St. Lucie Unit 2
Docket No. 50-389
Proposed License Amendment
Core Operating Limits Report (COLR)

ATTACHMENT 3 to L-97-280

ST. LUCIE UNIT 2 MARKED-UP TECHNICAL SPECIFICATION PAGES

Figure 3.1-1a
Allowable Time to Realign CRA vs. Initial P_R^T

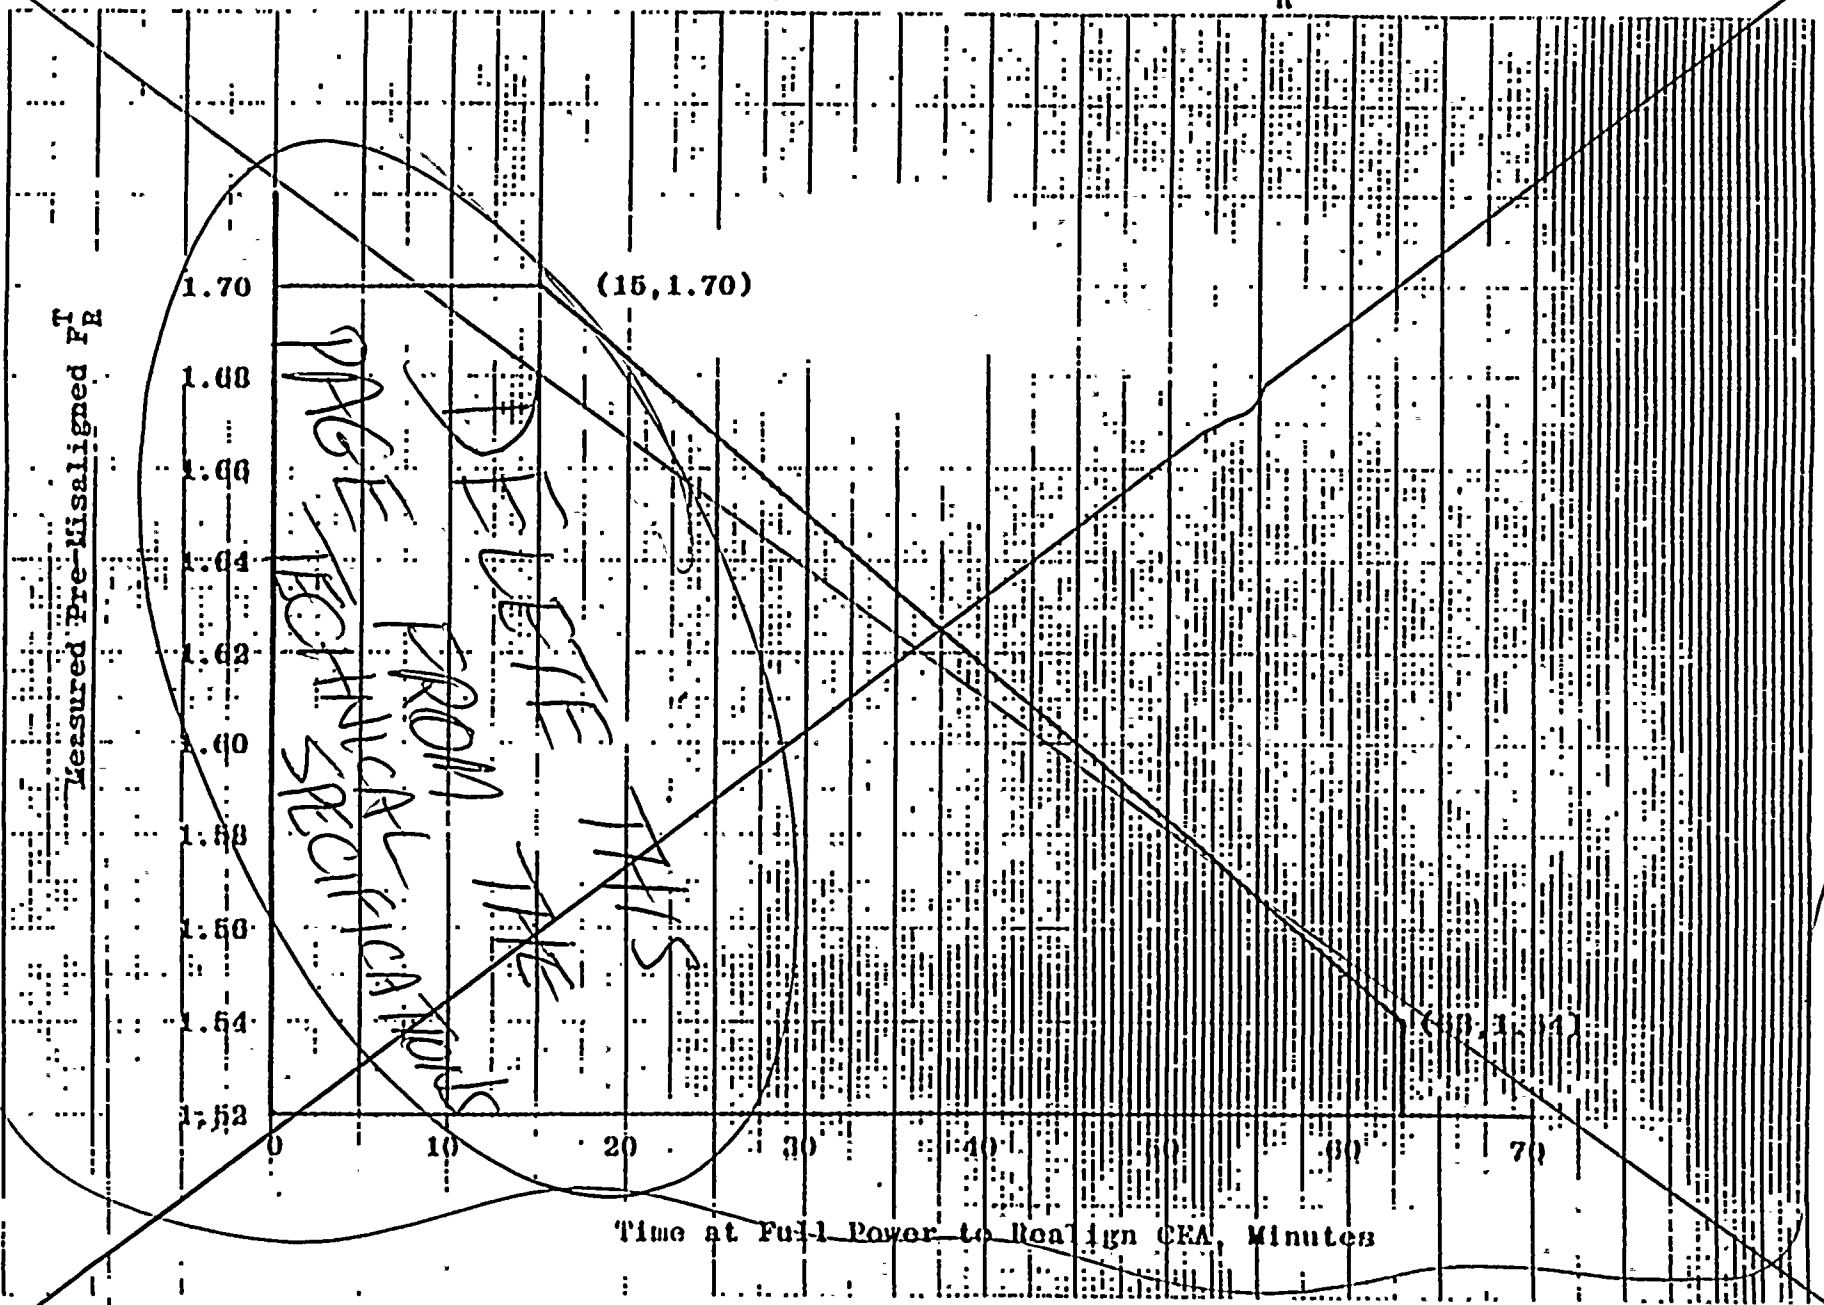
PAGE TECHNICAL SPECIFICATIONS
 DEFECT FROM THIS
 FROM THE

Figure 3.1.2

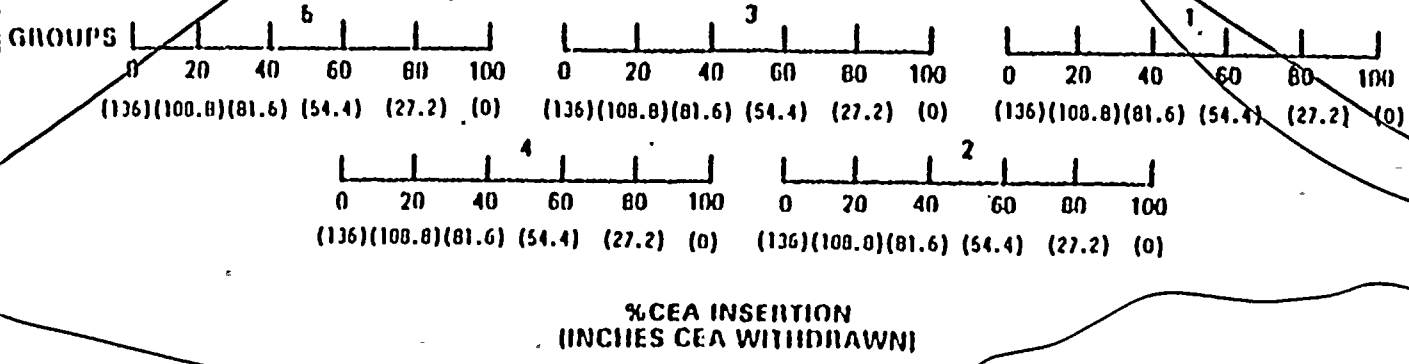
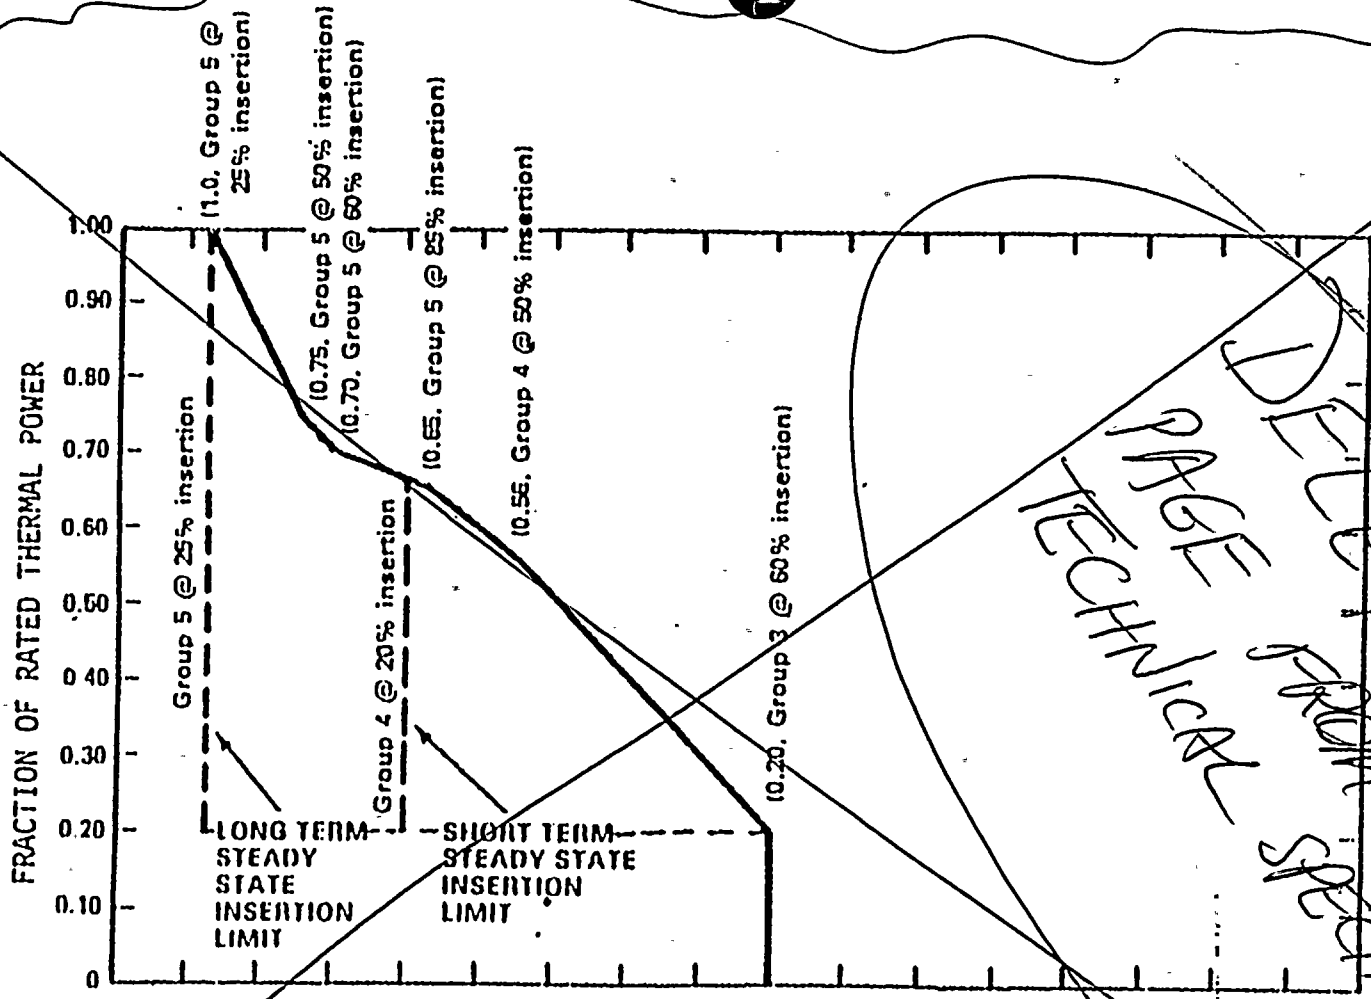
DELETE FROM THIS PAGE TECHNICAL SPECIFICATIONS

Figure 3.2-1
Allowable peak linear heat rate vs burnup

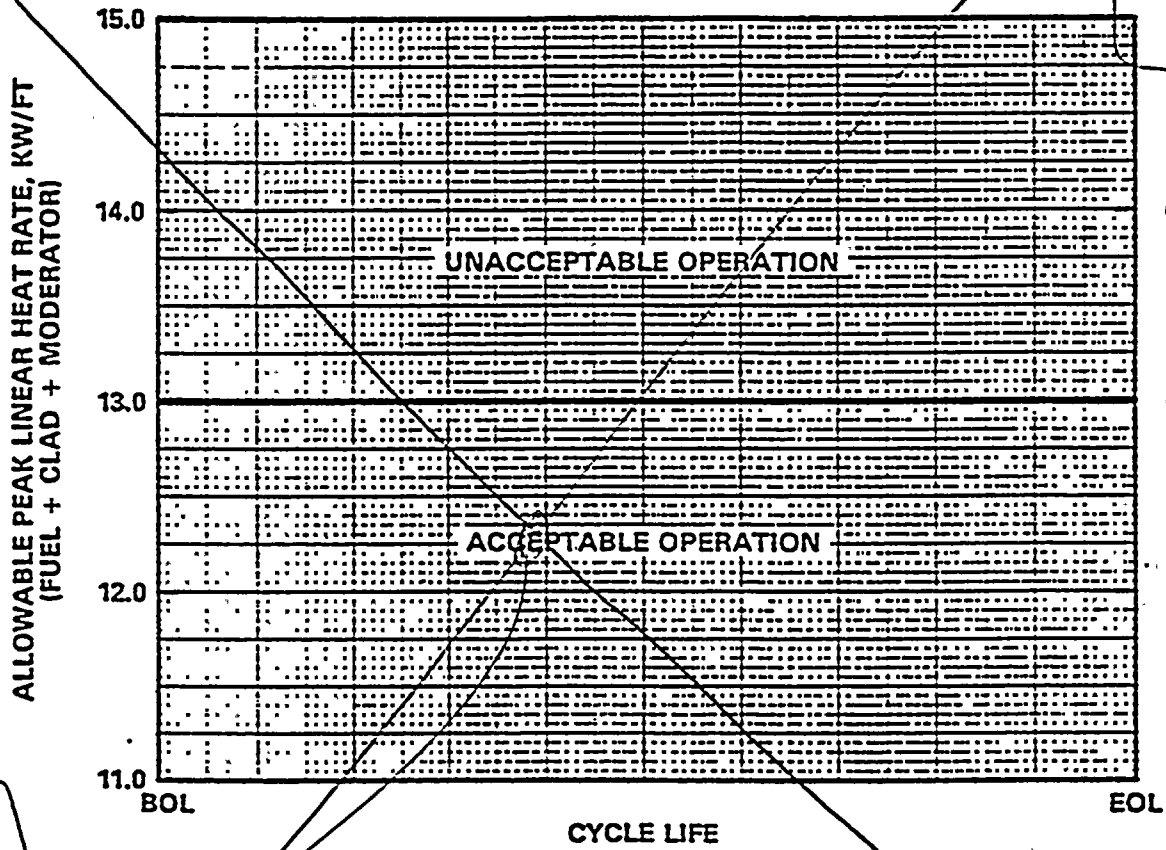
replace

Pages 3/4 2-4 (Amendment 42), 3/4 2-5 (Amendment 8), and 3/4 2-6 (Amendment 17) have been deleted from the Technical Specifications. The next page is 3/4 2-7.

FIGURE 3.2-2
AXIAL SHAPE INDEX VS. FRACTION OF MAXIMUM ALLOWABLE
POWER LEVEL PER SPECIFICATION 4.2.1.3

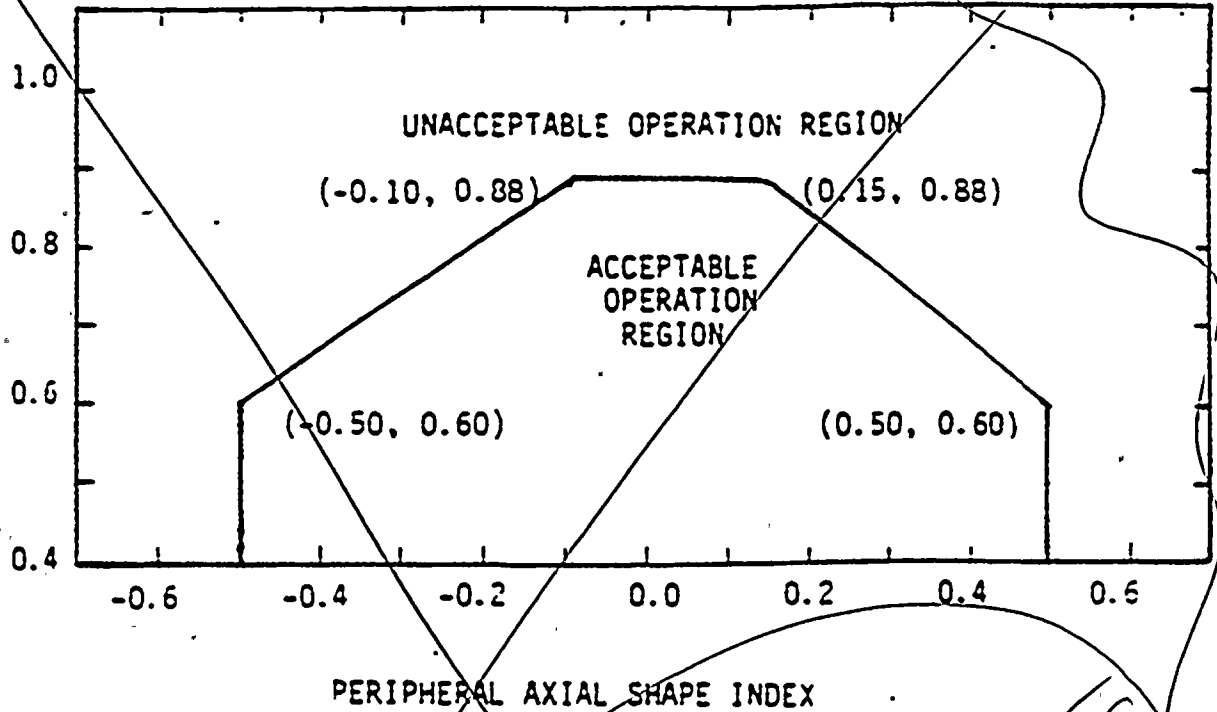
DELETE THIS PAGE FROM TS.
